Our Ref: 21999_R01_Haerses Road Quarry MOD 5_RFI Covering Letter_Final

**RE: Haerses Road Quarry Modification 5 (DA 165-7-2005 MOD 5)
Relocation of Site Office, Workshop and Weighbridge**

**RE: Haerses Road Quarry Modification
Sandstone cutting activities within the extraction area**

Re: Dust emissions from enclosed rock saw – Dixon Sand Haerses Road Quarry

FIGURE 2.1
Proposed Modification

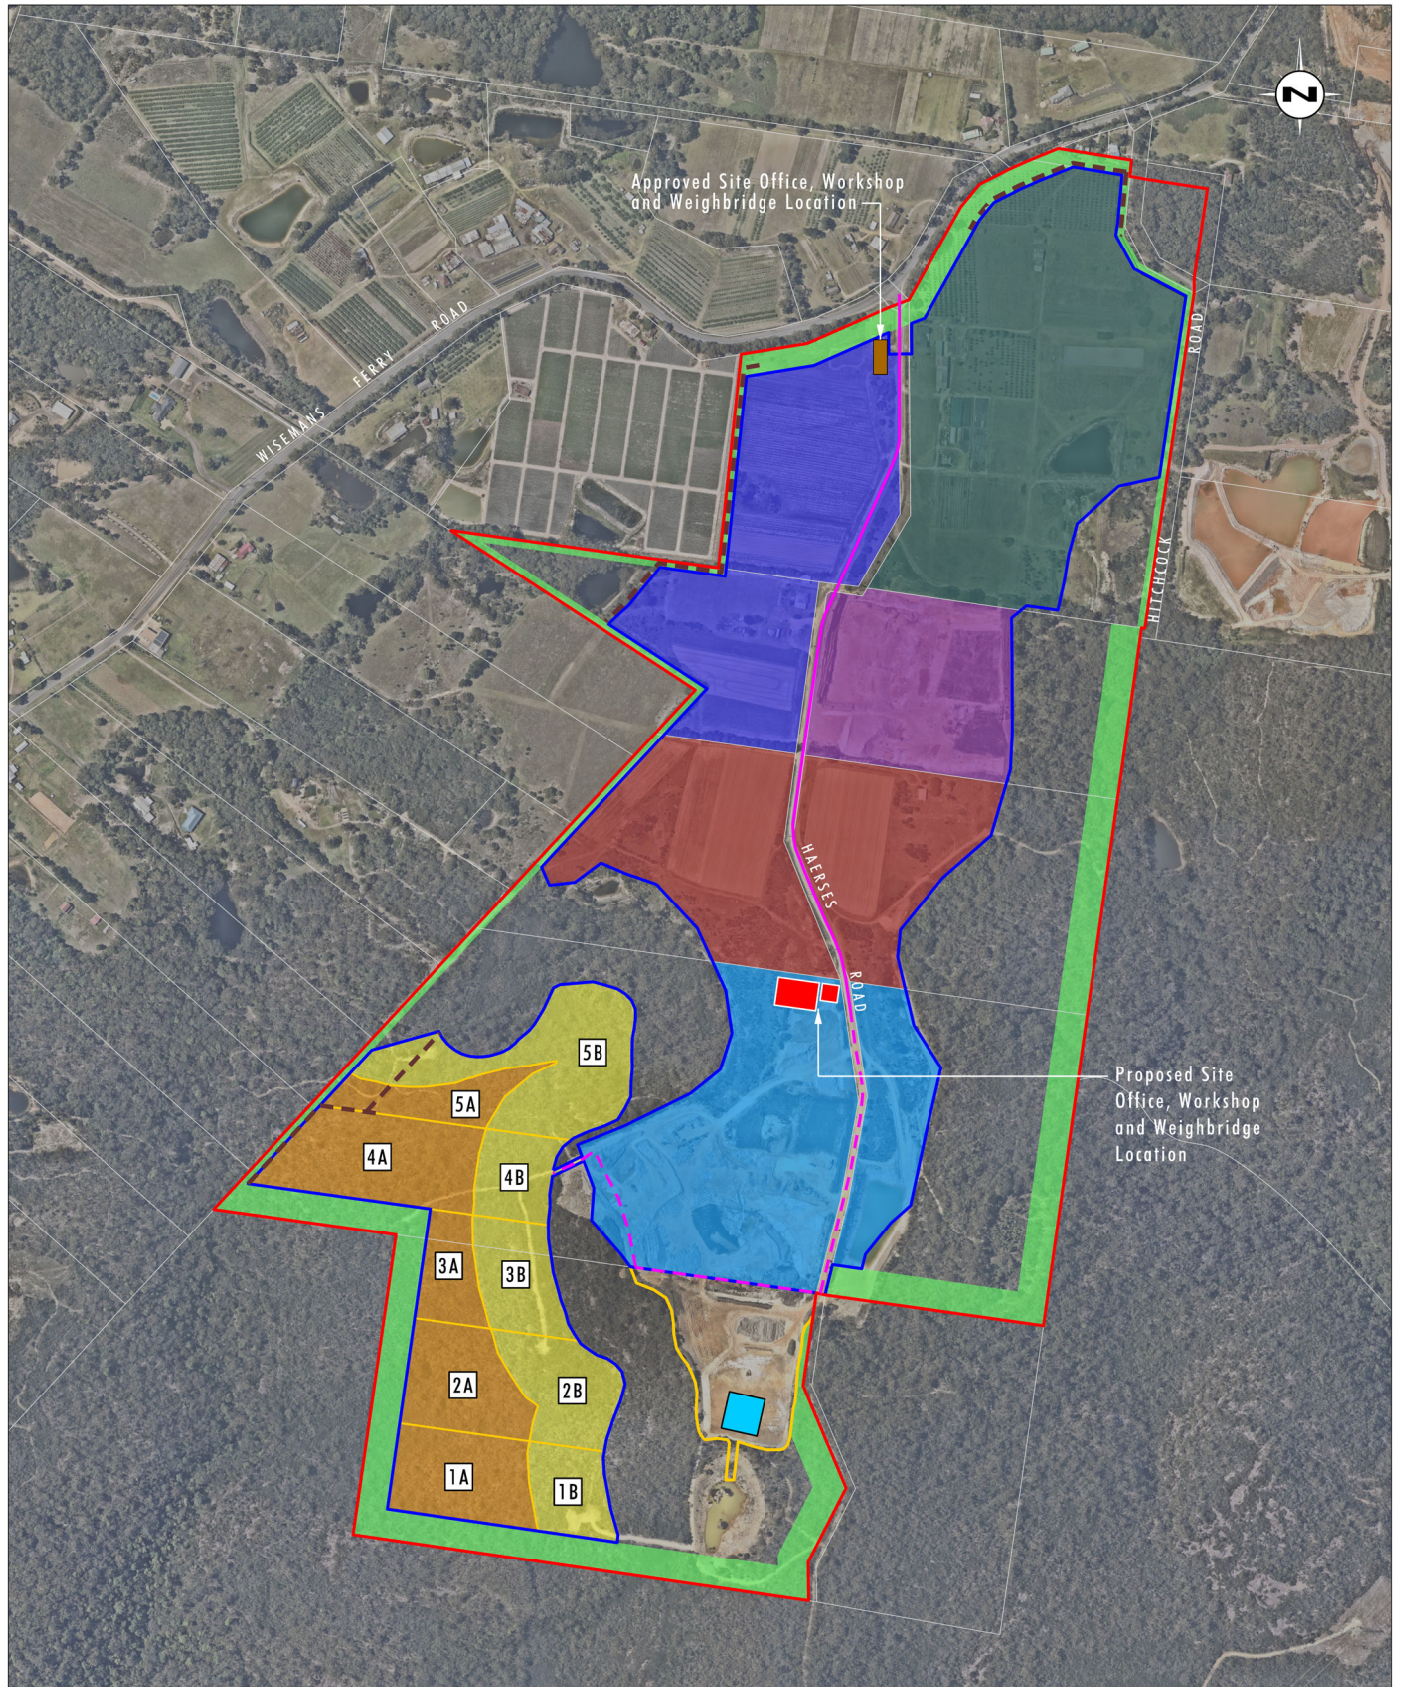
The EPA is concerned that the relocation of quarry activities within the quarry may create noise, vibration, and dust impacts for sensitive receptors.

The EPA is also concerned that the modelling used relates to development -modification 3, as such, the modelling may not be sufficient to understand the potential noise, vibration and dust impacts this proposed modification may have.

To avoid any doubt, no relocation of extraction activities is proposed. Dixon Sand currently extracts large blocks of sandstone from the approved Friable Sandstone Extraction Area (see **Figure 2.1**), by way of dozer ripping. The Proposed Modification would allow Dixon Sand to instead use an excavator with a hydraulic saw attachment for this purpose. This activity would occur wholly within the Quarry's approved extraction areas.

The only 'relocation' of activities proposed under MOD 5 involves the relocation of the approved site office, workshop, and weighbridge. As indicated in the MOD 5 Modification Report, Dixon Sand proposes to undertake final cutting and storage of sandstone blocks within the relocated workshop. This would involve wet cutting only, to suppress dust. Additionally, final cutting would occur within the enclosed shed structure, which would be engineered and constructed to achieve the necessary noise attenuation to ensure compliance with existing noise criteria under DA 165-7-2005 at all sensitive receivers (except where landowner agreements are in place).
